*ev*  
**Water Resources Department**

## FINAL ORDER

WATER RESOURCES DEPT  
SALEM, OREGON**Oregon Water Resources Department****REQUEST FOR WRITTEN APPROVAL TO USE CONSTRUCTION METHODS NOT  
INCLUDED IN OREGON ADMINISTRATIVE RULES 690-200 THROUGH 690-240**

- (7) Diagram showing the pertinent features of the proposed well design and construction: (attach additional pages if needed)

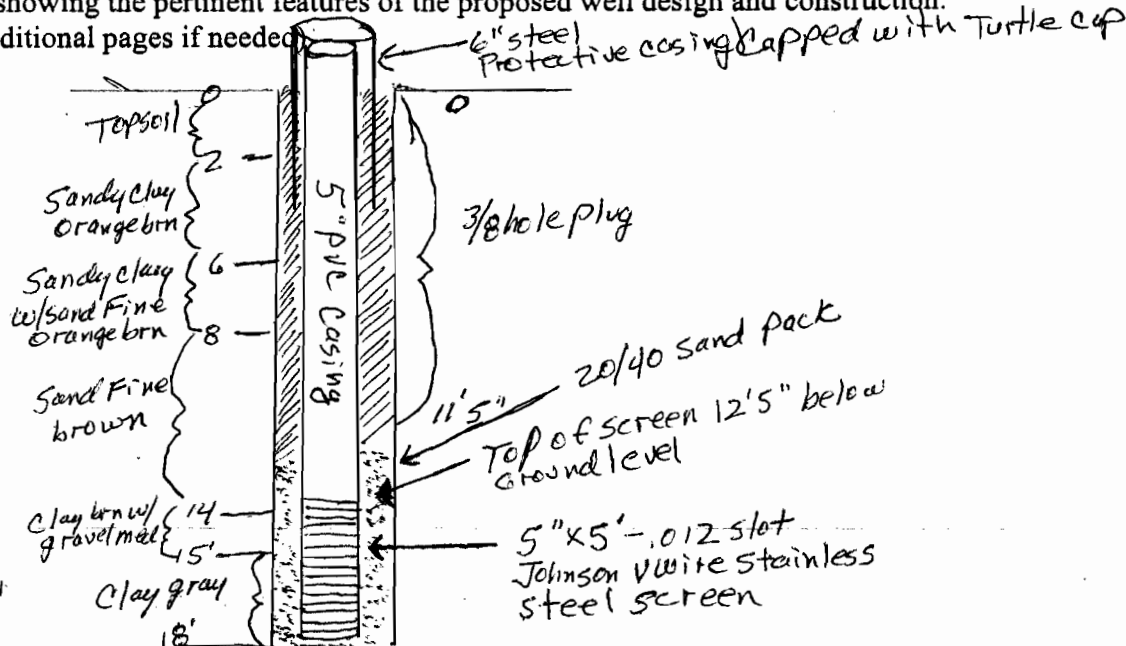
(5) The unusual site conditions which necessitate this request: Shallow water  
bearing formation in area hand dug wells 11-15'  
Deep holes that have been drilled to 150' in marine clays  
produce no water

Drill to bottom of water bearing formation and  
Seal as deep as practicle without shutting off  
water

The Special Standard request you submitted for owner: James A. Gregory, Start Card number 172295, is approved for the following: You may install a water well to a depth of approximately 18 feet below ground surface. The well shall be sealed to a depth of at least 11.5 feet bgs (See OAR 690-210-0150). All other well construction requirements must be adhered to. Your Special Standard request form is enclosed.
